**APPLICATION FOR
URBAN DESIGN COMMISSION
REVIEW AND APPROVAL**

PROJECT ADDRESS: 1849 Northport Drive

SALES DRAWINGS: NORTHSIDE TOWN CENTER - Pylon Sign
northsidecenter 04-1.gip

REPORT OF: URBAN DESIGN COMMISSION	PRESENTED: March 22, 2006
TITLE: 2801-3101 North Sherman Avenue and 1725-1865 Northport Drive – Comprehensive Design Review of Signage. 12 th Ald. Dist.	REFERRED: REREFERRED: REPORTED BACK:
AUTHOR: Alan J. Martin, Secretary	ADOPTED: POF:
DATED: March 22, 2006	ID NUMBER:

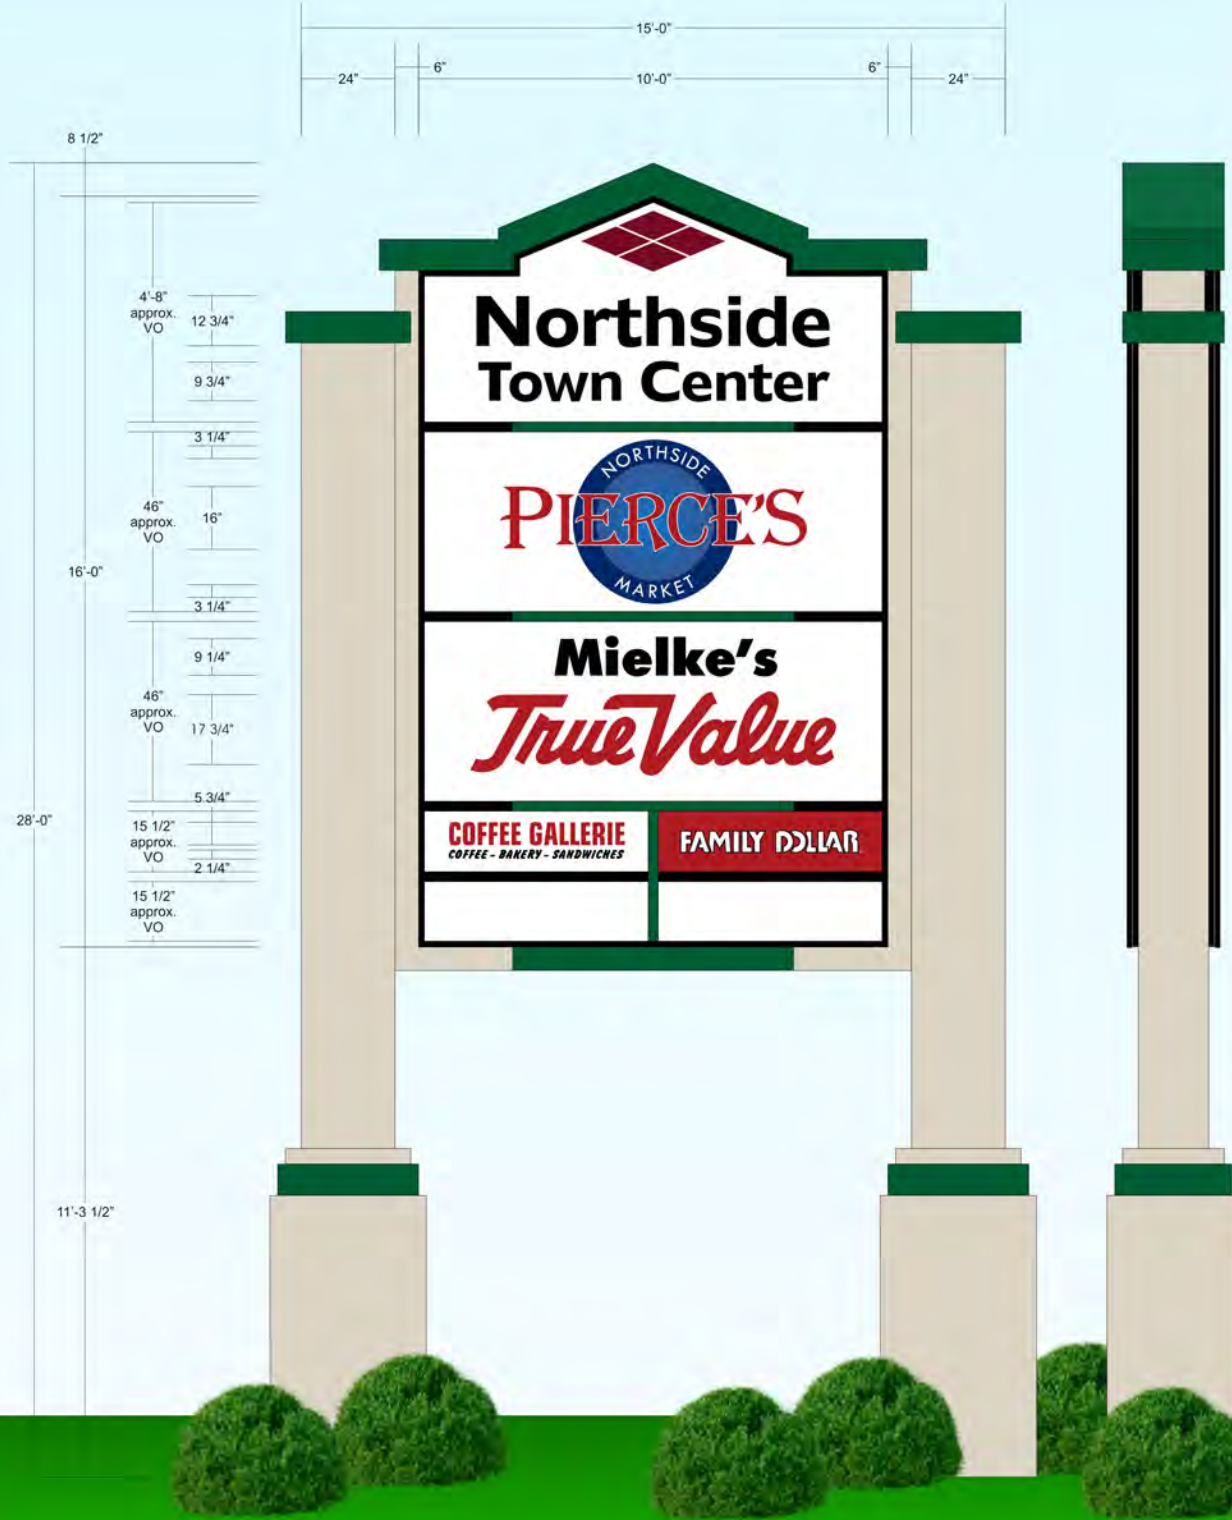
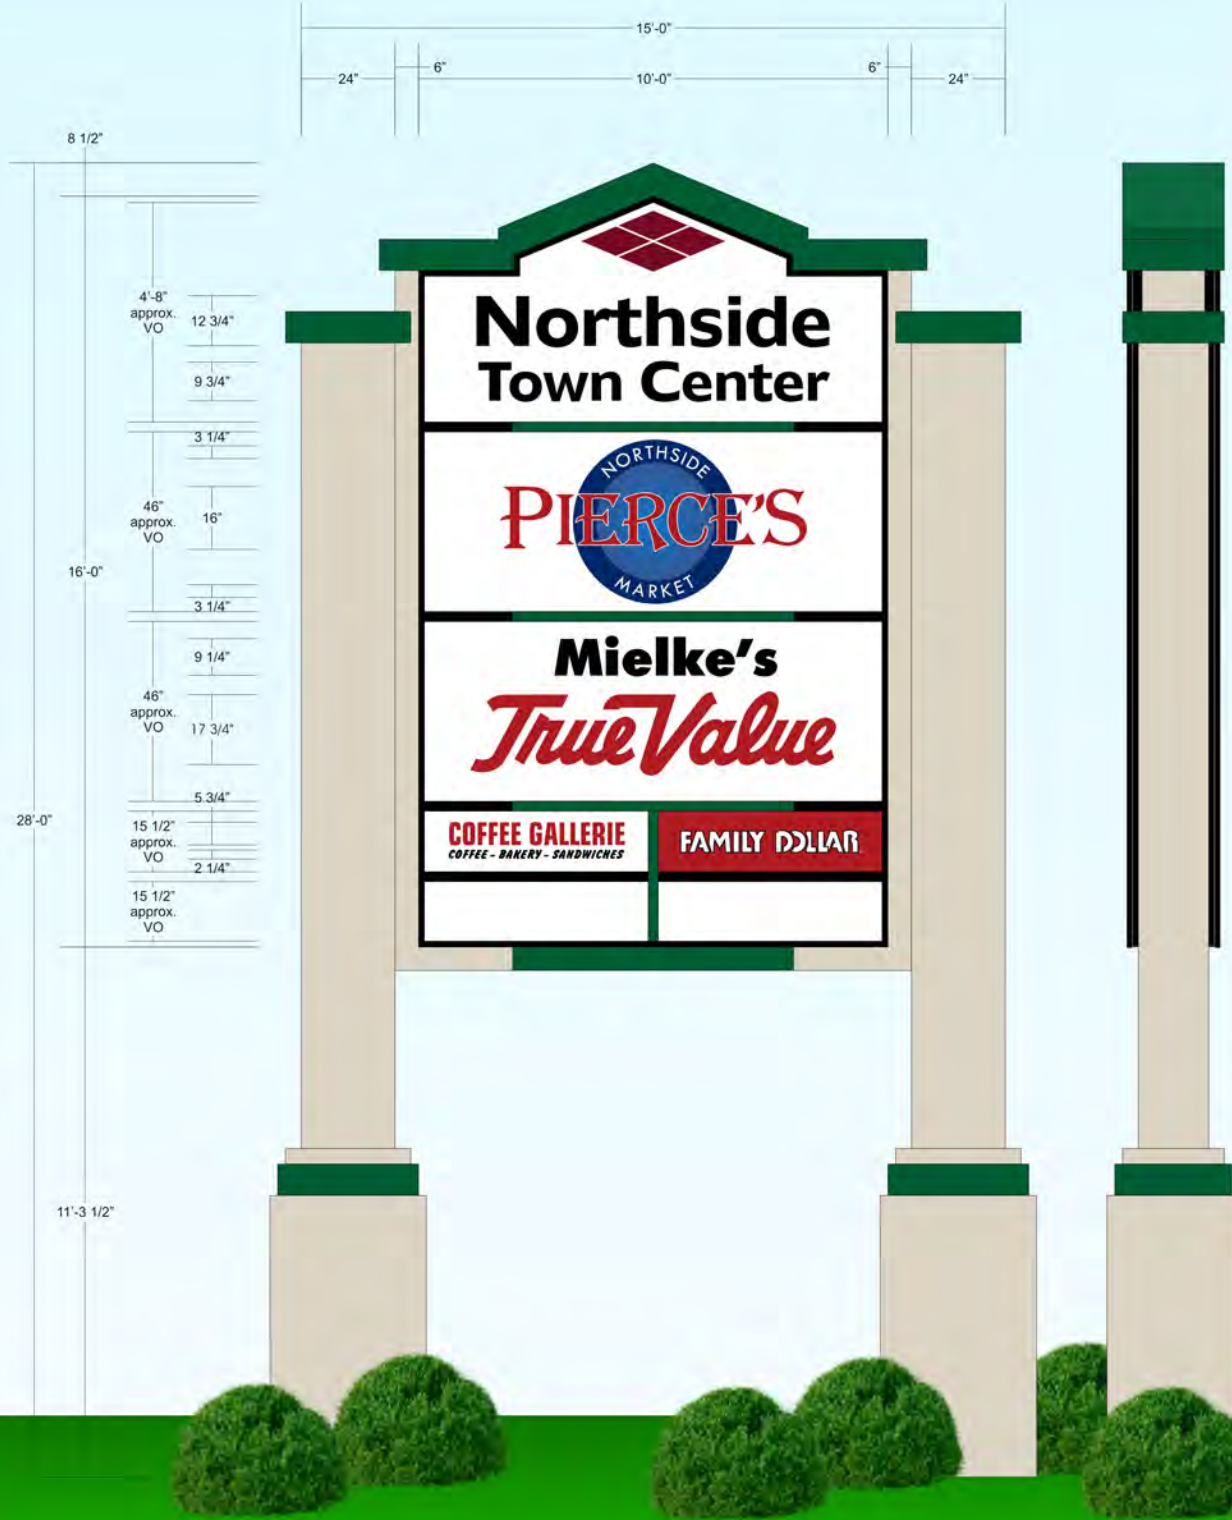
- The proposed Northport Drive ground sign is too large with the extensions on the main portion of the sign looking too cluttered.
- Generally speaking signage is well done and fits with architectural elements of the center.
- Relative to the Northport sign, the center top feature for the Northside Town Center should repeat the peak element treatment as proposed for the North Sherman Avenue ground sign. In addition, support the parking regulation sign.
- Eliminate wing walls on the Northport Drive sign and incorporate tenant signage below by making the overall sign taller.
- Consider taking off the Town Center graphic on the Northport Drive side of the center to get more tenant signage and make both signs alike within their overall appearance and top treatment.
- The Northport sign should be consistent at the top and be branded the same as proposed with Sherman Avenue.

- The top treatment on both the Northport Drive and Sherman Avenue ground signs should be as proposed with the Sherman Avenue sign and match.
- Change parking regulation sign to refer to the parking with the size of the sign approved as proposed.
- The Northport Drive ground sign shall come back for further consideration with elimination of the winged extensions. Consideration of increased height if necessary and the same top treatment as the Sherman Avenue sign or the applicant is to return for consideration of a new proposal.
- The Sherman Avenue wall sign proposed on the tower element identifying the Northside Town Center is approved on either face of the tower element.

- Proposed Northport sign too big. Northport and Sherman Avenue signs should have same arrangement of signs. Southwest corner should have only town center signs.
- Nice architectural sign reflecting existing building. Mass concerns on sign with wings.
- Mixed review: Most of the signage package is fine, however, the proposed “sign with wings” is really quite awful.
- Vertical sign on Northport preferable.

Pylon location.
Current and proposed.

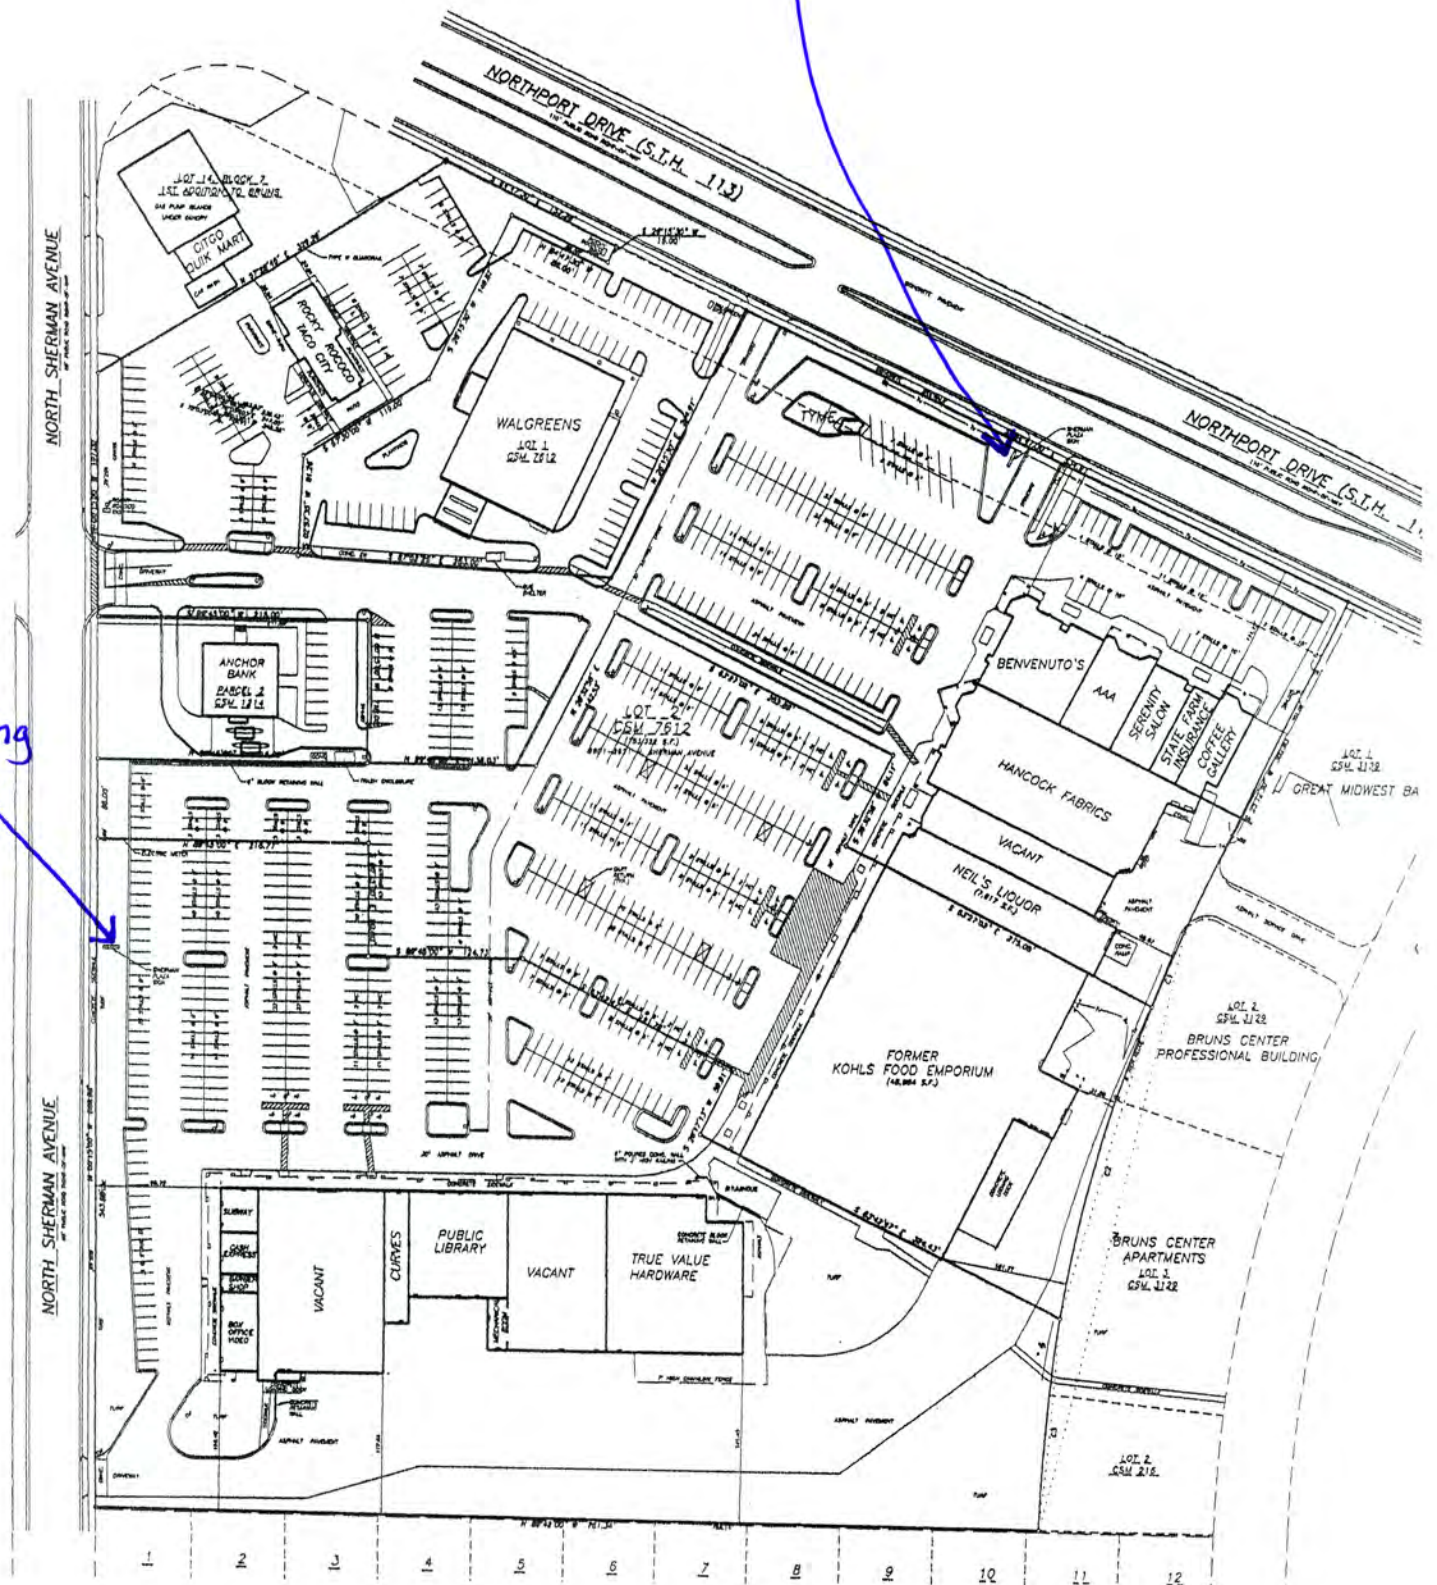
matching
pylon.
